Planning and Zoning Commission - Special Meeting AGENDA

**STAFF REPORT
KETCHUM PLANNING AND ZONING COMMISSION
MEETING OF JULY 27, 2021**

PROJECT: Crossbuck West Townhomes

APPLICATION: Design Review and Townhouse Subdivision Preliminary Plat

Sheet No:
L2

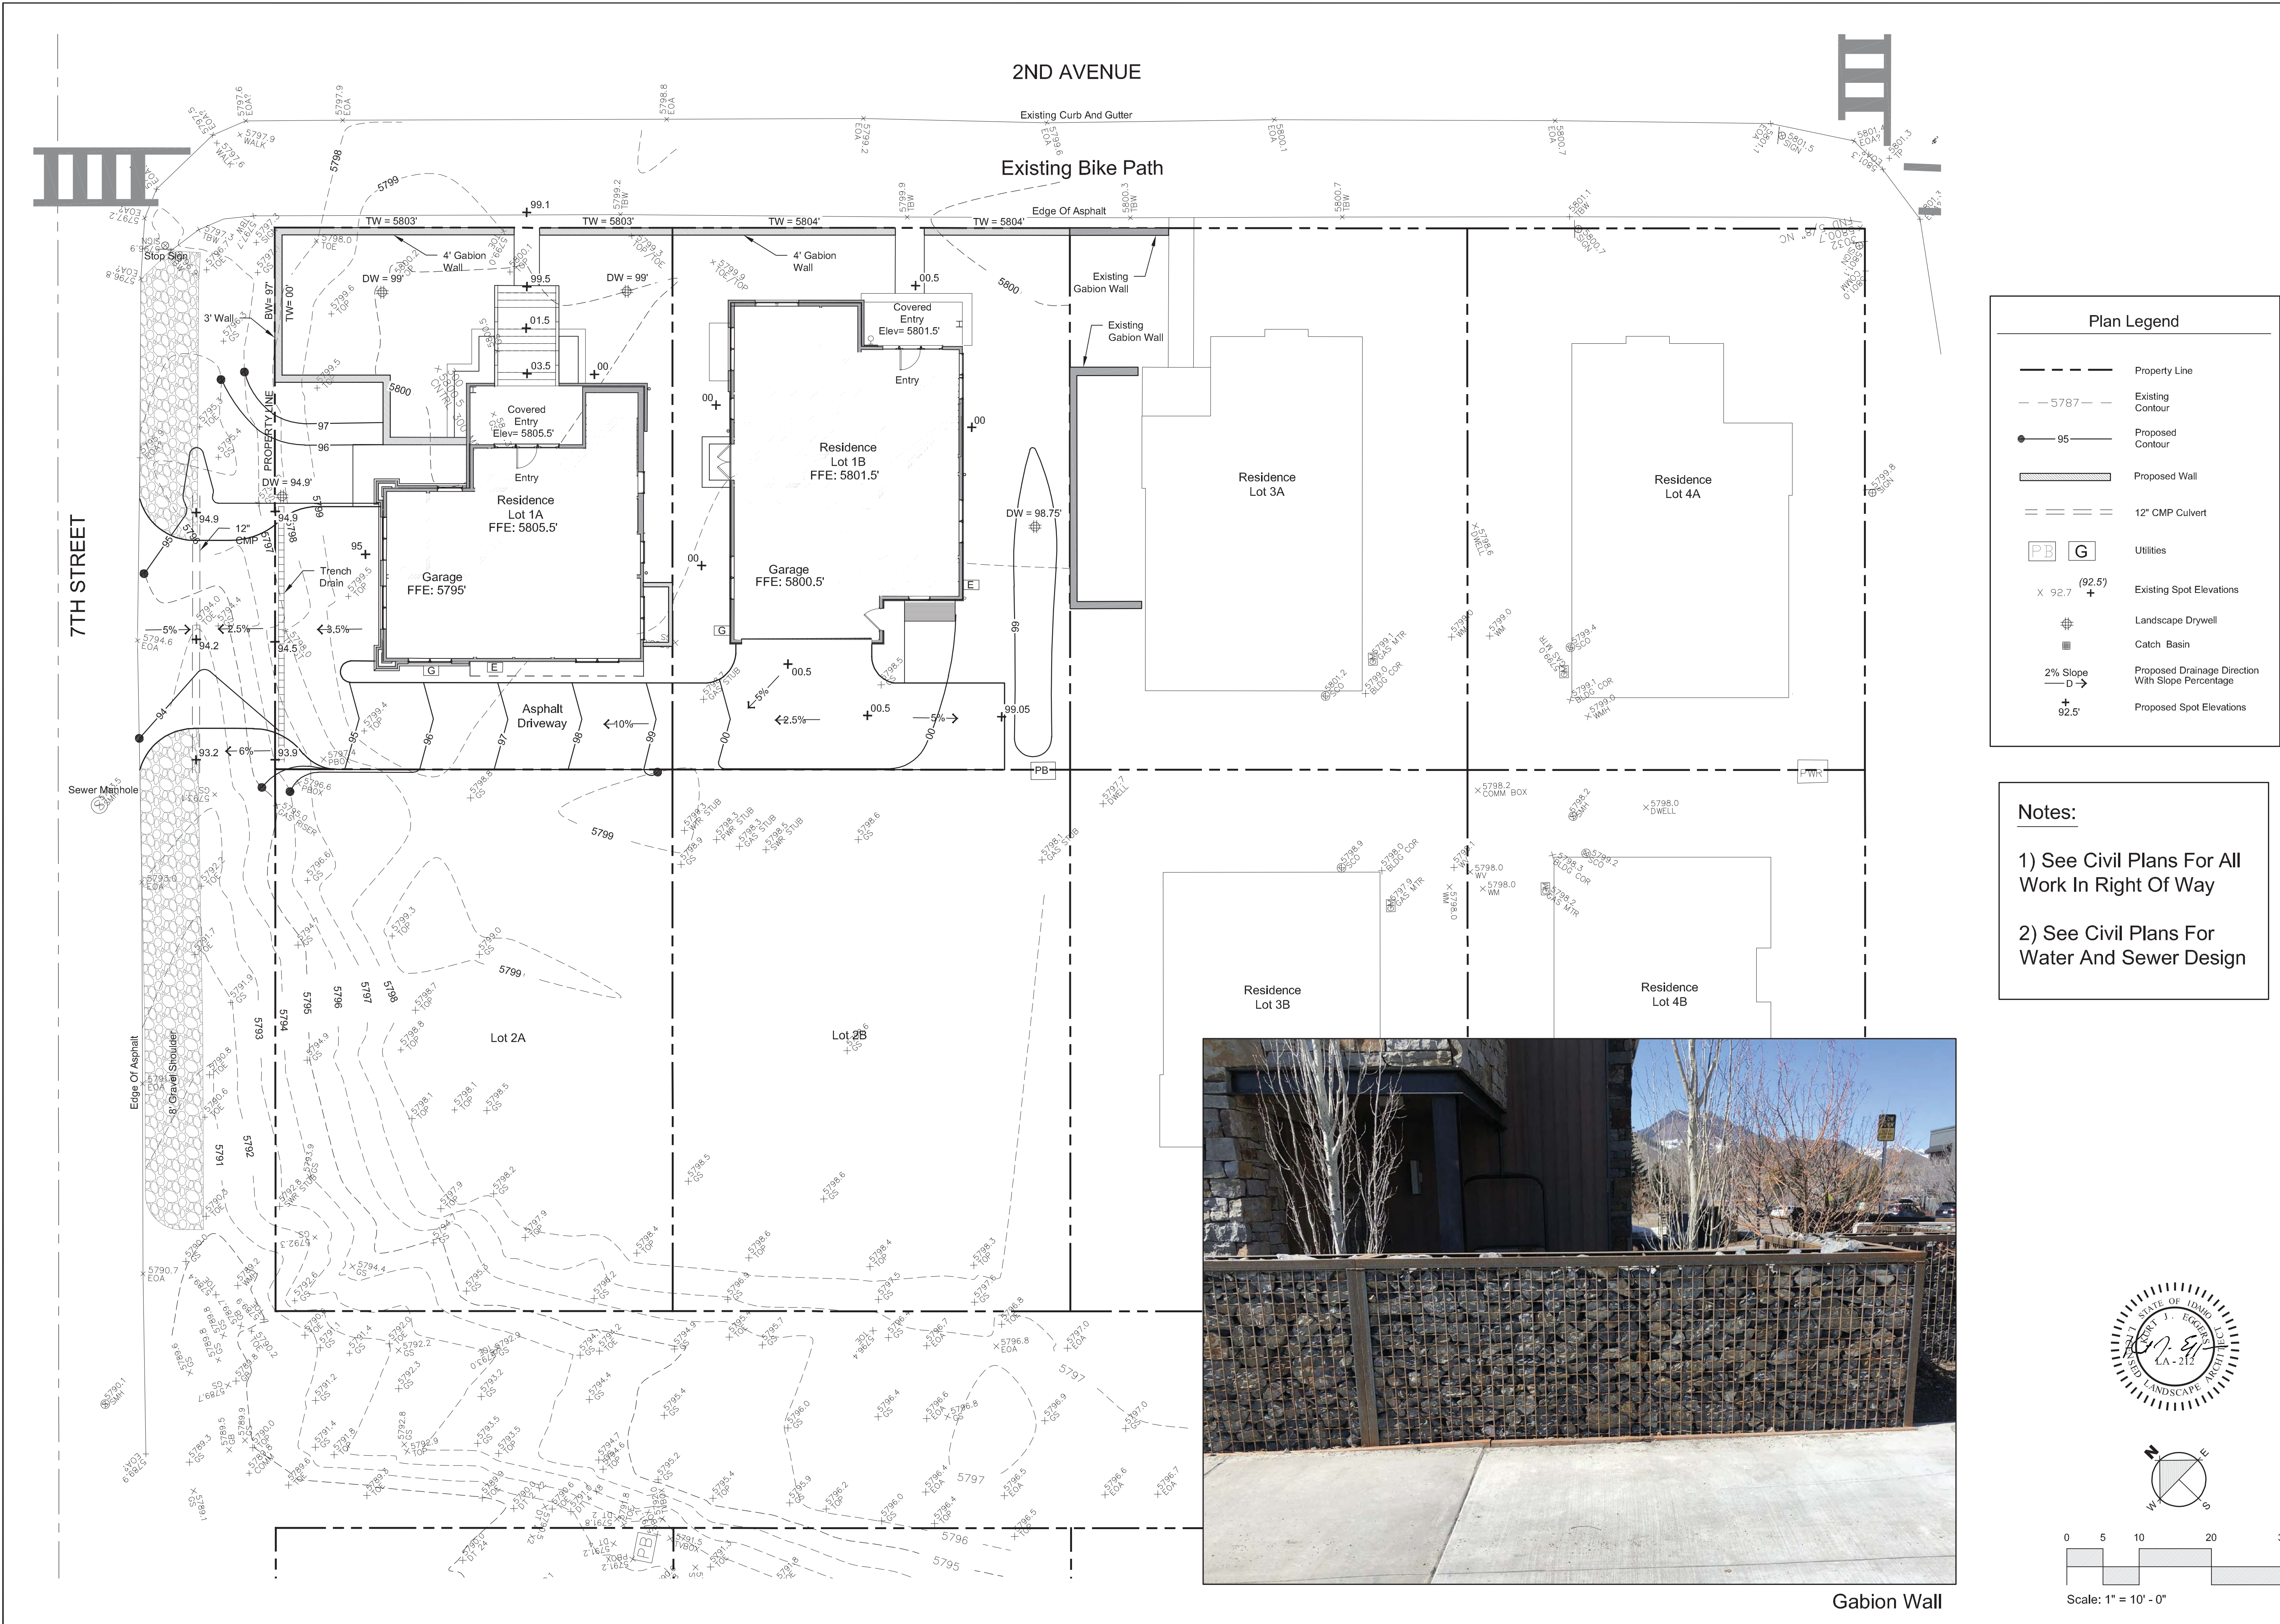
Staff Comments	The project plans include drainage improvements. The drainage improvements are indicated on Sheet L2 and the drywell specifications are provided on the civil drawings.
<input checked="" type="checkbox"/>	<input type="checkbox"/>	<input type="checkbox"/>	16.04.030.J.14	The location of all drainage canals and structures, the proposed method of disposing of runoff water, and the location and size of all drainage easements, whether they are located within or outside of the proposed plat.
			Staff Comments	All drainage improvements have been indicated on the project plans. No drainage canals are required or proposed.
<input checked="" type="checkbox"/>	<input type="checkbox"/>	<input type="checkbox"/>	16.04.030.J.15	Vicinity map drawn to approximate scale showing the location of the proposed subdivision in reference to existing and/or proposed arterials and collector streets.
			Staff Comments	The project plans include a vicinity map.

A-7A

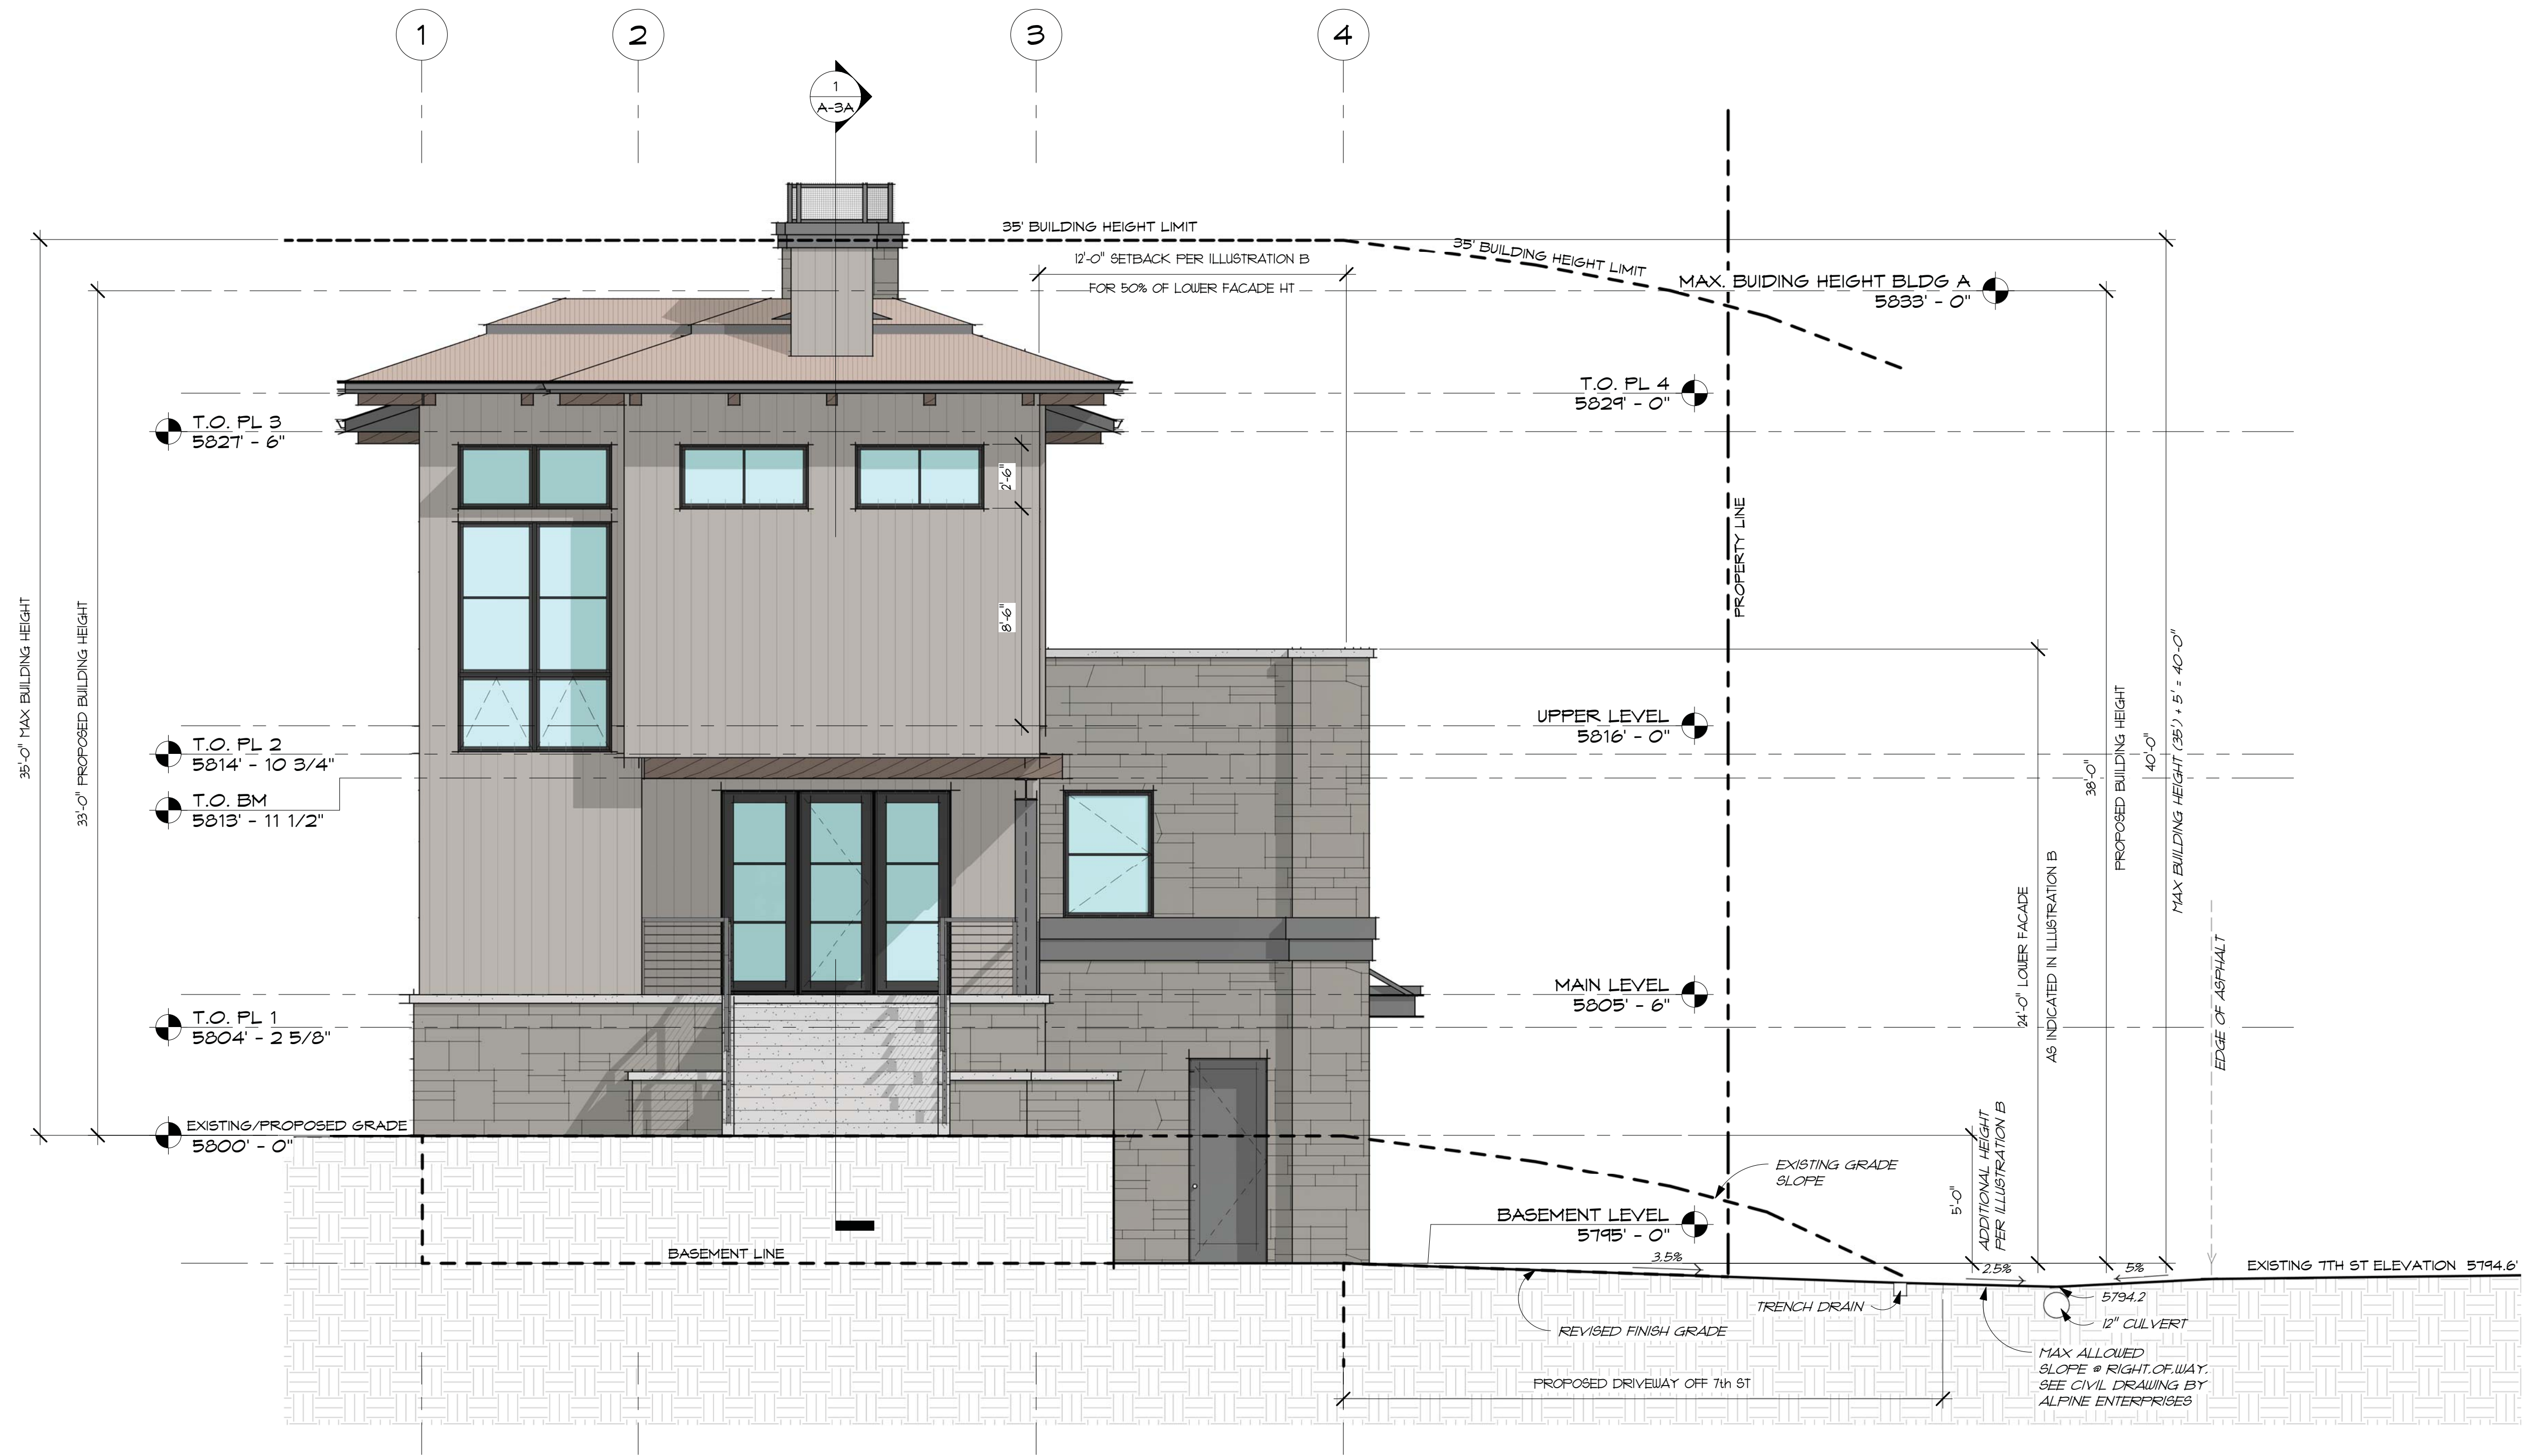
The townhome units are boxy and bulky buildings. Unlike the existing Crossbuck units and the townhome units proposed on adjacent Lot 2A, the McNee units have maximum building heights of 35 feet and 38 feet in height. As shown on Sheet A-7A of the project plans, townhome unit A takes advantage of the additional 5 feet of building height provided for in Ketchum Municipal Code §17.08.020 due to the topography of the site. The maximum height of townhome unit A from lowest grade to highest point of the roof is 38 feet. The mass of the building's rectangular volumes is overbearing. The design utilizes
